MEMORANDUM

To: Design Review Board
From: Tony Leavitt, Senior Planner
Date: June 8, 2020
File No.: DRV20-00118
Subject: **EMERALD MIXED USE PROJECT
DESIGN RESPONSE CONFERENCE**

A.11

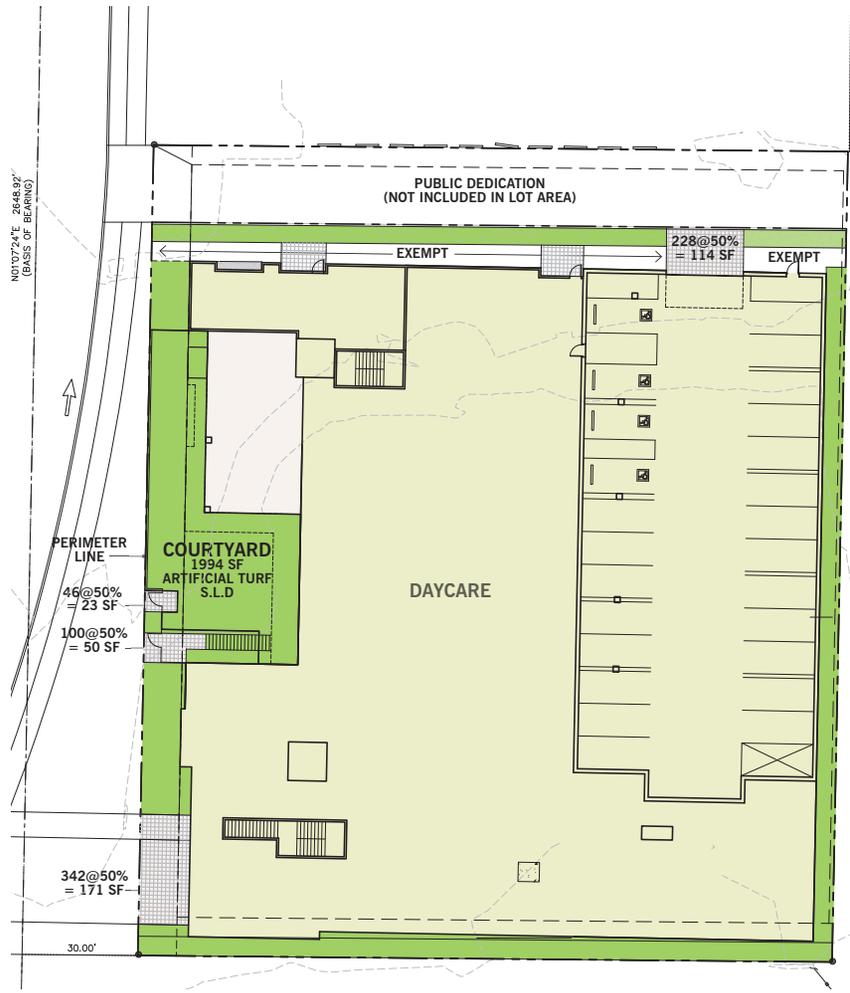
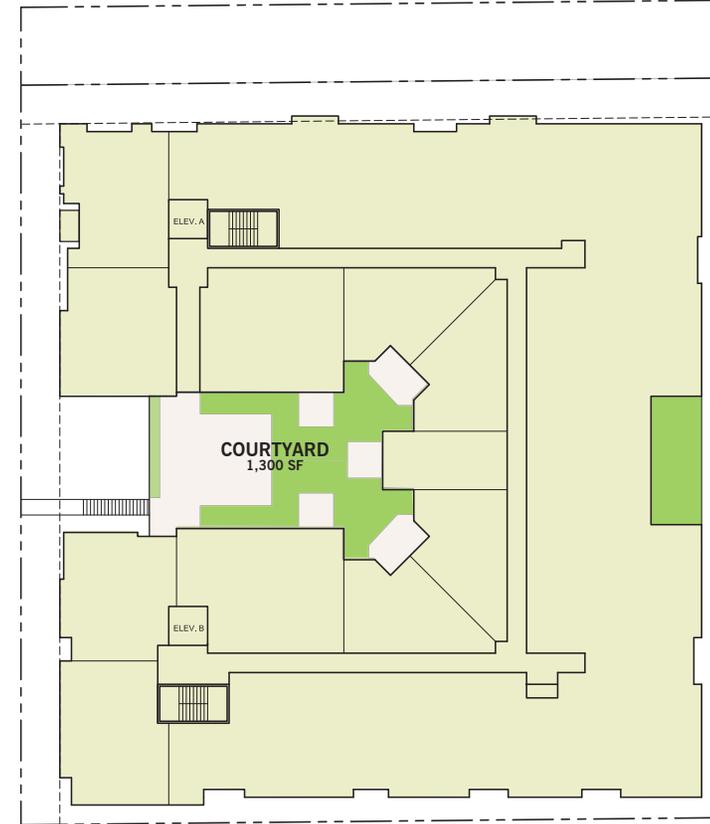
The applicant has submitted revised plans based on Public Works Department direction regarding right-of-way dedication requirements (see Attachment 2, Sheet A.11) and detailed plans for any pedestrian sidewalks or walkways including a lighting plan (see Attachment 2, Sheets A.11 and L.5)

The proposed plans show the Public Works approved access from 116TH Avenue NE and the right-of-way dedication along the north property line (see Attachment 2, Sheet A.11). The sidewalk and landscape strip will be located in an easement while the northern 20 feet will be dedicated to the City.

The trash room is located on the P1 Lobby level. A trash staging route has been provided on Attachment 2, Sheet A.11..

SOUTH ELEVATION
SCALE: 1/32" = 1'-0"

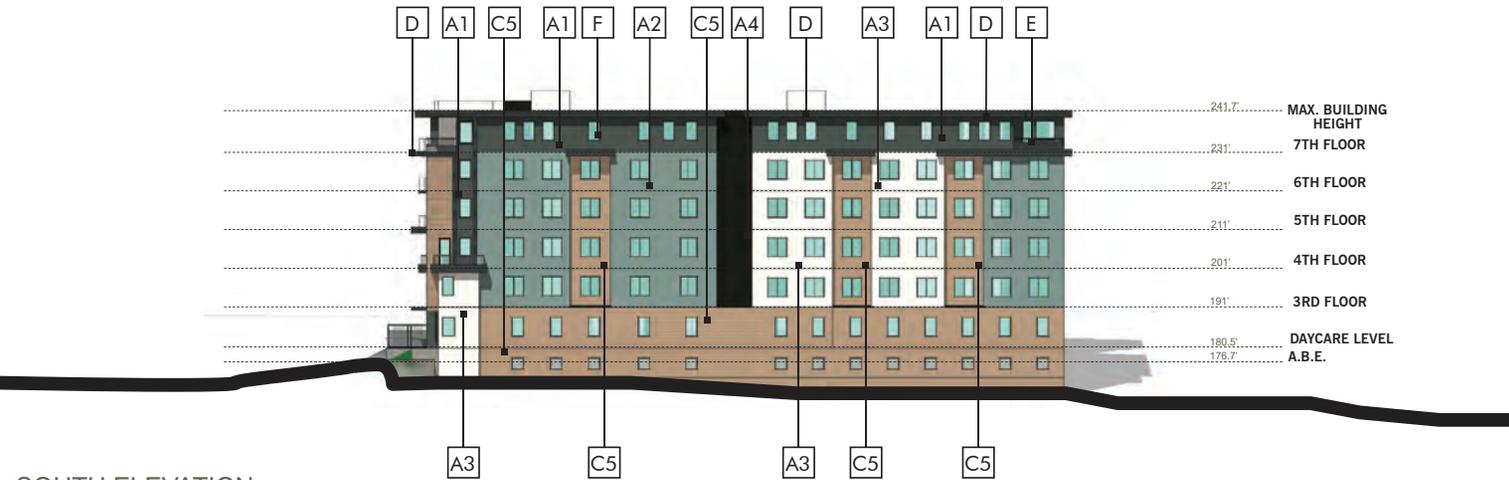
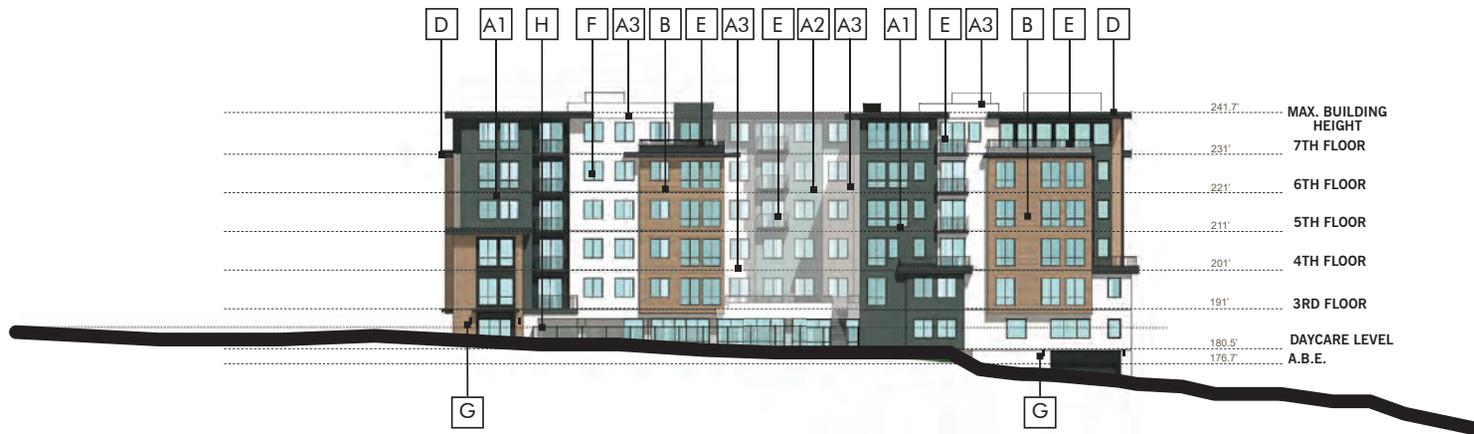
- *The proposal does a good job of incorporating fenestration, vertical modulation and architectural elements (including balconies, awnings and material changes) to help break up the west façade and add visual interest from the adjoining right-of-way.*

- *While a majority of the parking garage is below grade along the west façade, the parking garage entrance and surrounding exposure is missing material changes and landscaping that would help screen the area and add visual interest.*

Attachment 2, Sheets A.22 and 23 contain color elevation drawings and callouts for the proposed building materials. The DRB should provide feedback to the applicant regarding the proposed materials and colors. The DRB should discuss whether additional or larger samples of materials and colors should be provided at a future Design Response Conference.

A.24

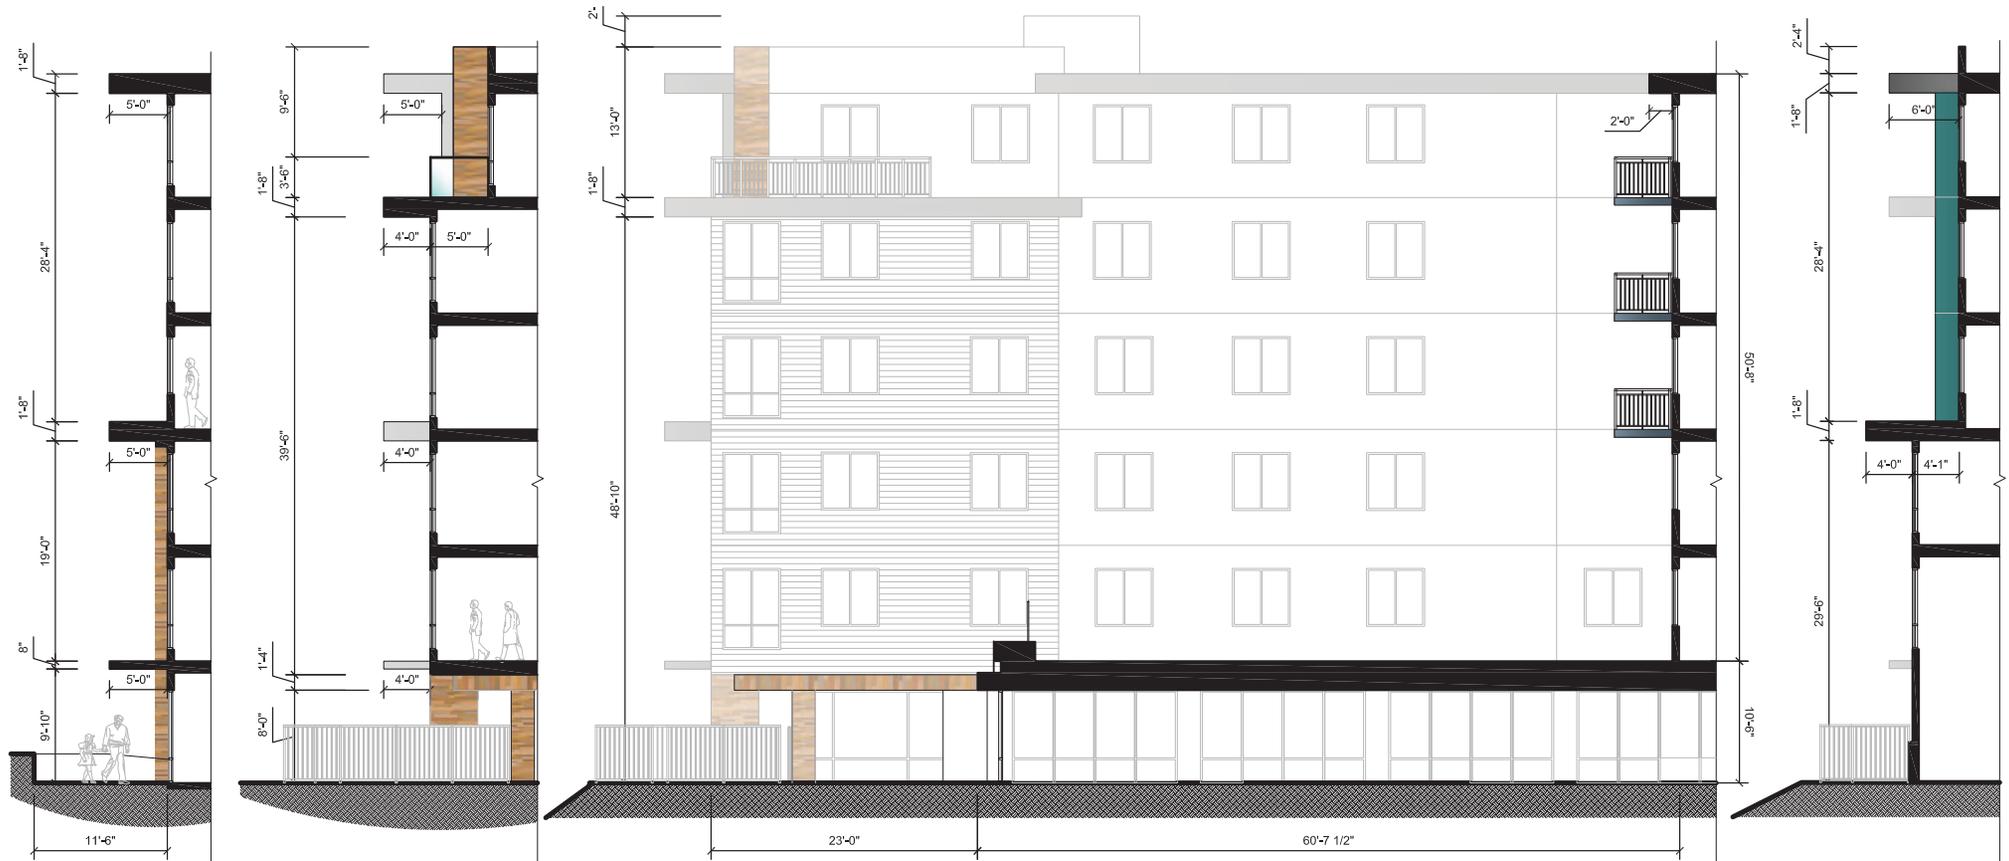
Detailed wall sections throughout the building are shown on Sheet A.24 of Attachment 2.

PLANTING PLAN

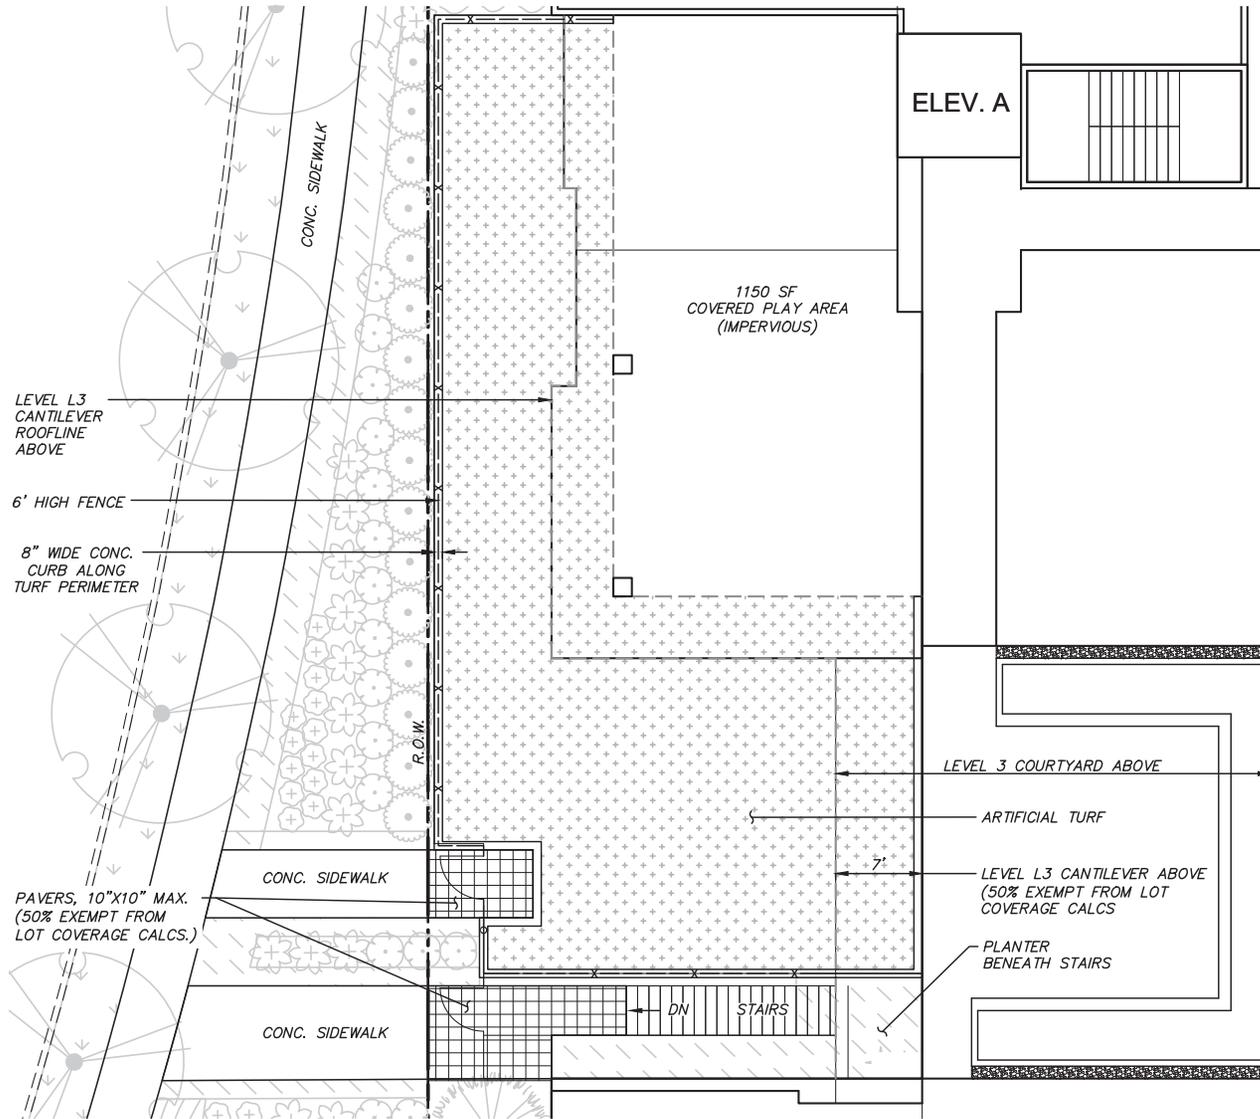
The applicant has submitted a detailed landscape plan (see Sheet L.2) and Level 3 Courtyard Plan (see Attachment 2, Sheet L.4).

- *What changes are needed to the landscape plan?*
- *Are there other opportunities for additional landscaping?*
